Model: Be-C1	Date: 19-Sep-08	No.: RD046002f
--------------	-----------------	----------------

Subject: Firmware Release Note: Engine		Prepared by: F.Noguchi	
From: 2nd PP Tech Service Sect., PP Tech Service Dept.			
Classification:	<input type="checkbox"/> Troubleshooting	<input type="checkbox"/> Part information	<input type="checkbox"/> Action required
	<input type="checkbox"/> Mechanical	<input type="checkbox"/> Electrical	<input type="checkbox"/> Service manual revision
	<input type="checkbox"/> Paper path	<input type="checkbox"/> Transmit/receive	<input type="checkbox"/> Retrofit information
	<input type="checkbox"/> Product Safety	<input checked="" type="checkbox"/> Other (Firmware)	<input checked="" type="checkbox"/> Tier 2

Subject: Touch panel problem		Prepared by: F.Noguchi	
From: 2nd Tech Support Sec. Service Support Dept.			
Classification:	<input checked="" type="checkbox"/> Troubleshooting	<input type="checkbox"/> Part information	<input type="checkbox"/> Action required
	<input type="checkbox"/> Mechanical	<input type="checkbox"/> Electrical	<input type="checkbox"/> Service manual revision
	<input type="checkbox"/> Paper path	<input type="checkbox"/> Transmit/receive

How to distinguish the new parts from the old parts

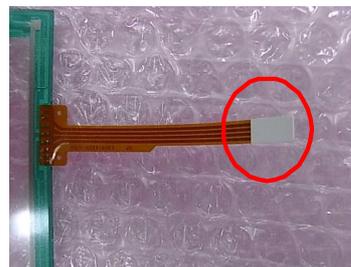
The adhesive that binds electrodes to the touch panel surface contains a polymer that tends to expand under normal office environmental conditions.

Service parts: The adhesive was changed to one that will not expand under conditions of standard office environments.

Old parts:
The tip of the electrode is **brown**.

New parts:
The tip of the electrode is **white**.

New part number	Description	Q'ty
B0651371	CLOTH HOLDER	1

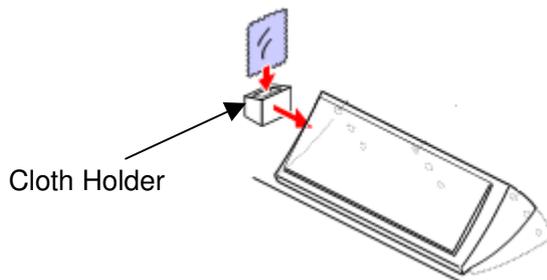
Change: The cloth holder is now bundled at the factory from May 2010 production.
Reason: In accordance with requests from the field.
